Informal document GRSP-51-11
(51st GRSP, 22–25 May 2012,
agenda item 17)

Proposal for the 02 series of amendments to UN Regulation No. 100
(Specific requirements for the electric power train)

Submitted by the Chairman of the group of interested experts on Rechargeable Energy Storage
Systems (REESS) */

The text reproduced below was prepared by the Chairman of the group of interested experts on Rechargeable Energy Storage Systems (REESS) and aims to be a more readable version of ECE/TRANS/WP.29/GRSP/2012/10.

Figure 1: Comparison of proposed with UN38.3 load curve

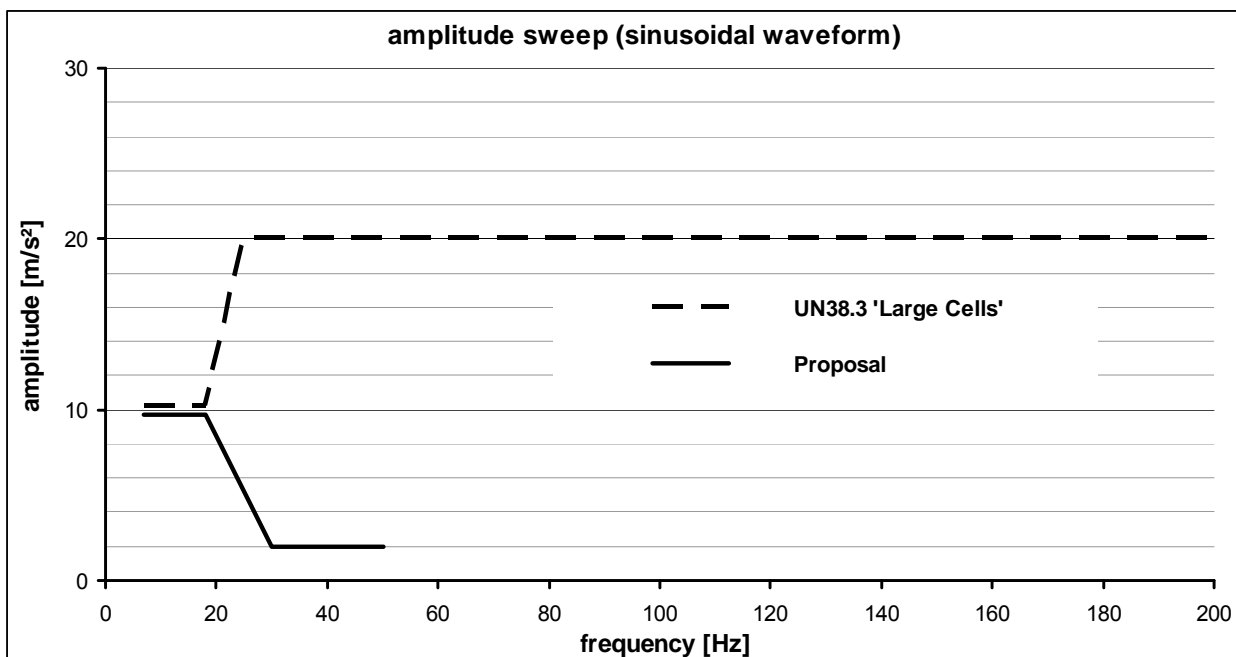
As UN38.3 sign-off may often also be mandatory for REESS subject to this regulation, having the opportunity to cover this test with UN38.3, test T3, is seen as an efficient approach. However the load curve per UN38.3 is assessed as too severe for automotive applications. Despite the recent lowering of the high frequency amplitude in UN38.3 from 8g to 2g for "large cells" with masses more than 500gr, even this amplitude is still not considered representative for the typical sizes of REESS in vehicles, with a mass of 200kg or more. Particularly the height of the amplitudes above 18Hz is seen as unrealistic and does not correlate to the loads seen in road vehicles (except for hypothetical cases of REESSs mounted close to or onto a combustion engine), as due to the stiffness of vehicle bodies in relation to the module weight frequencies higher than this cannot be transmitted at significant energy levels.

This regulation therefore uses the same frequency vertices as UN38.3 test T3, albeit those for smaller cells, but lowers the load curve above 18Hz and truncates it at 50Hz.

The test duration is also aligned with UN38.3, Test T3, requiring 12 transitions from the minimum to the maximum frequency and back within 15min., resulting in a total test duration of 3h.

Fig. 1: Thermal Shock Profile

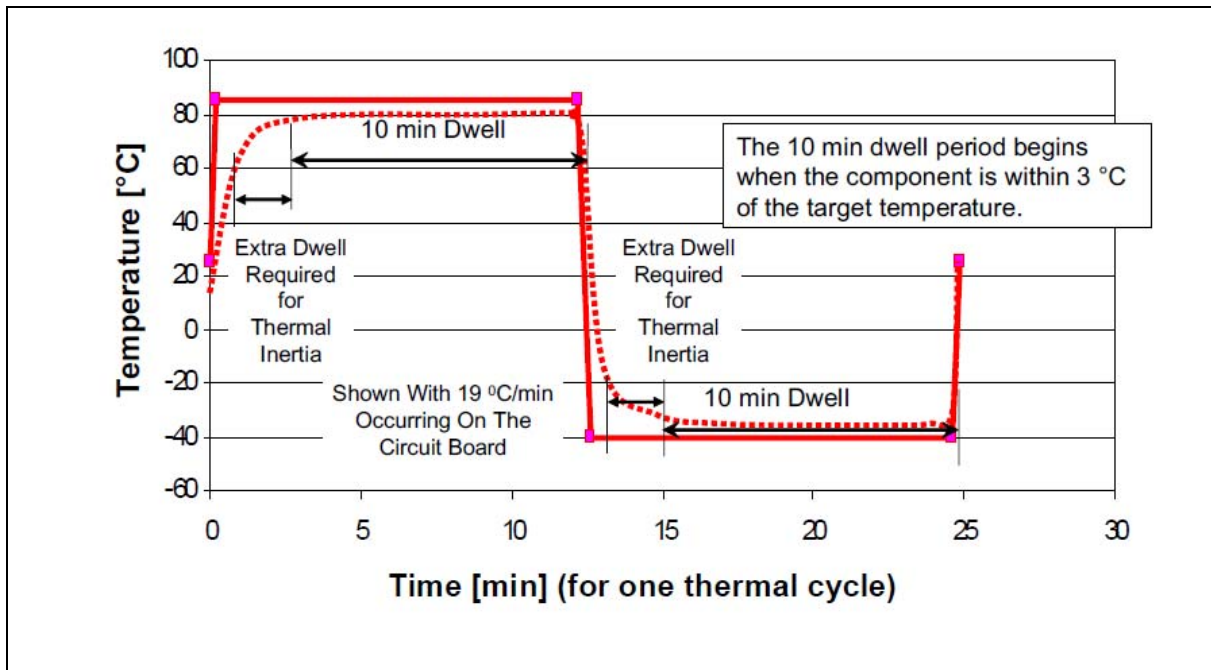
The Thermal Shock and Cycling Test shall verify that the REESS is immune to thermal fatigue and contact degradation that is caused by temperature changes and possible miss-matching of the CTE of materials.

Similar tests are a significant test within validation of electrical components and subsystems. Also, a thermal shock and cycling test is part of the test sequence of transportation tests according to UN 38.3.

Since the REESS has a different thermal mass and has different operation and storage temperature ranges than typical electric / electronic components, a modification of the test conditions i.e. lower maximum temperature and longer dwell time is needed.

Figure1: location of REESS

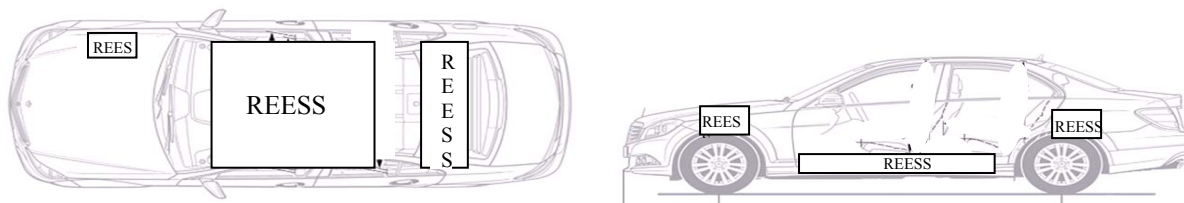
The loads have been derived from REESS contact loads which have been observed on vehicle crash tests according to ECE-R12, ECE-R94 and ECE-R95, using electric and hybrid-electric vehicles which are currently available on the market. The REESS were installed in various installation positions (see figure 1).

The contact loads onto the REESS observed during above tests and simulations did in no case exceed 100kN (see table 1).

Figure 2: Cumulative frequency and 5th percentile in cars registered 2000 and later (SAE 2011-01-0545 Analysis of Fuel Cell Vehicles Equipped with Compressed Hydrogen Storage Systems from a Road Accident Safety Perspective)

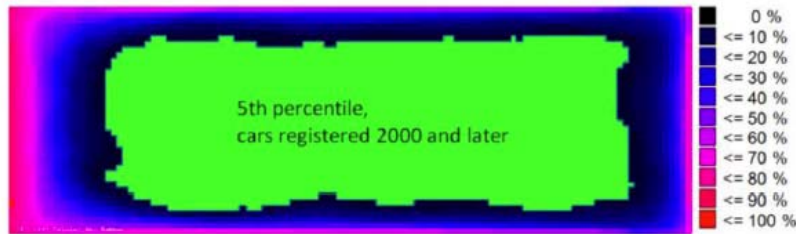
Figure 1 shows, that the REESS in the investigated vehicles are not installed in the extreme positions in the front or the rear of the vehicle. This is confirmed by vehicle independent investigations (SAE 2011-01-0545 Analysis of Fuel Cell Vehicles Equipped with Compressed Hydrogen Storage Systems from a Road Accident Safety Perspective) that show that statistically the highest rates of the deformation will be observed at the front end and, at a smaller level, at the rear end of the vehicle (see

figure 2). Therefore, these installation locations shall be excluded if the REESS is approved according to the generic 100 kN integrity test according to annex 8D.

Figure 1. Mean of temperature readings on a vehicle Mock-up during different “R34” exposures

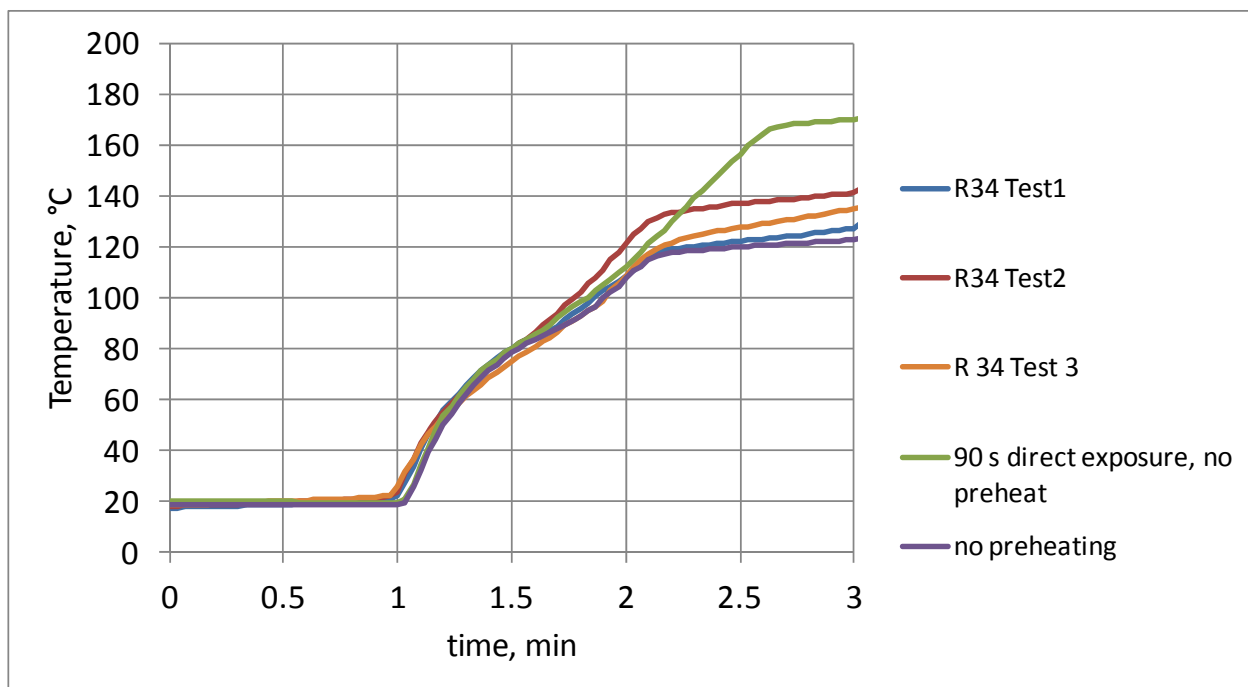
The test is required for REESS placed at a level lower than 1.5 m above ground. The 1.5 m limit is due to that the fire impact will be significantly lower at this height especially considering that there will be plenty of material in between the fire and the REESS when it is placed at this height.

The requirement for plastic fuel tanks in R34 is that it should pass 3 tests. The requirements in paragraph 6.5 and Annex 8E are only for one test. In order to compensate for potential variations in fire exposure the direct exposure phase of the test has been increased by 10 s. The 10 s change was determined based on experiments presented in Figure 1 below where temperatures were measured on a simulated vehicle during the exposure from 3 R34 tests and modified versions of the R34 test (e.g. 90 s direct exposure and no preheat period and 60 s direct exposure, no preheat period). These curves also confirm that the preheating period can be omitted if these 10s extra are used.

Figure 2. Temperature readings above a 2.2 m² pool

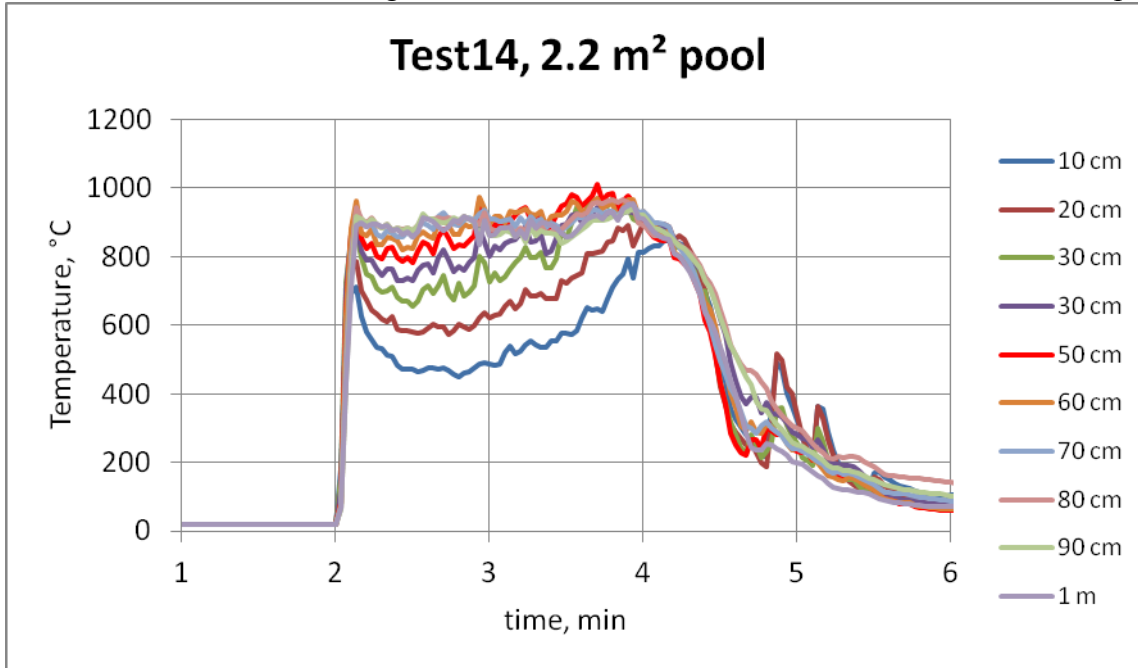
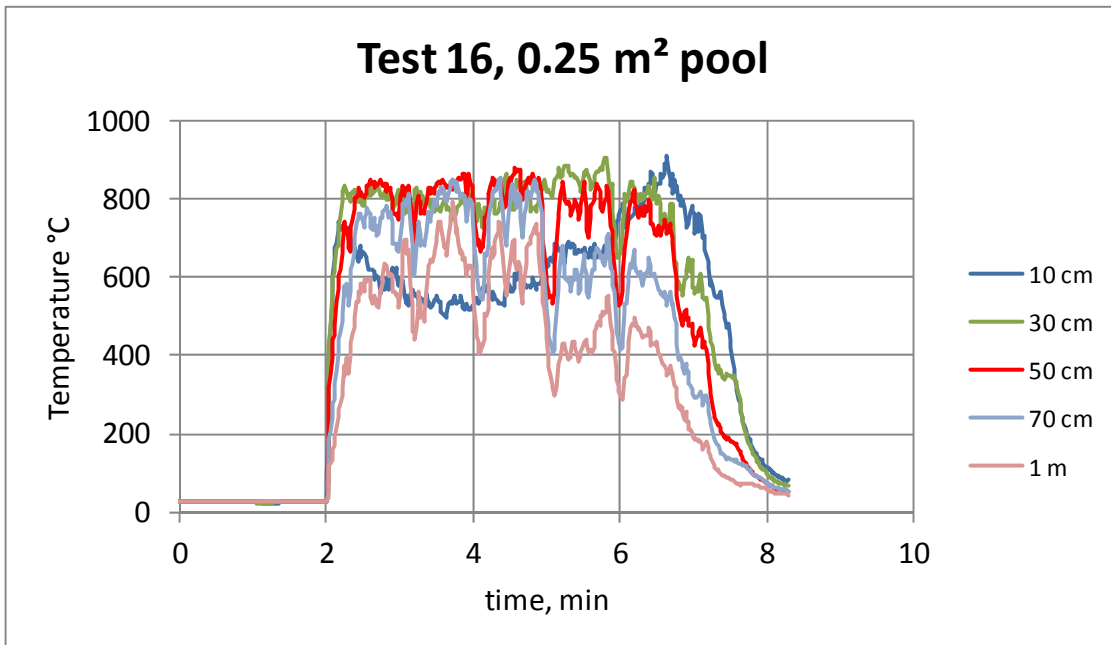
A testing procedure on component level is also suggested. This test procedure is similar to the procedure for the vehicle test. As this procedure should be valid for all possible placements of the REESS, the height at which the REESS is placed during the test is determined to represent the worst case. Experiments were conducted in which the temperature as a function of height was measured above the fuel surface for various pool sizes, some are presented in Figures 2 and 3 below. Based on the results of these tests, a height above the fuel surface of 50 cm was selected for component testing.
